## Service Information Bulletin

### System version overview 4.0 to 4.5.1

- Since release of system version 4, several system upgrades have been released.
- This document gives an overview of all current system versions.

Figure 1: Gauge protection unmounted

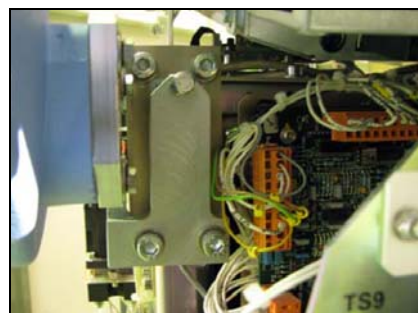
- ATP console A3024-121 T is replaced by A3024-121 U  
The spare part has been updated accordingly:  
SC+A3024-121U      ATP console CPU PCB Revision U
- Gauge protections  
Mechanical protections (left and right) have been developed to protect the gauges against deformation caused by rough handling, hits against the handle, etc.  
No spare part or upgrade kit is available, only introduced in production.
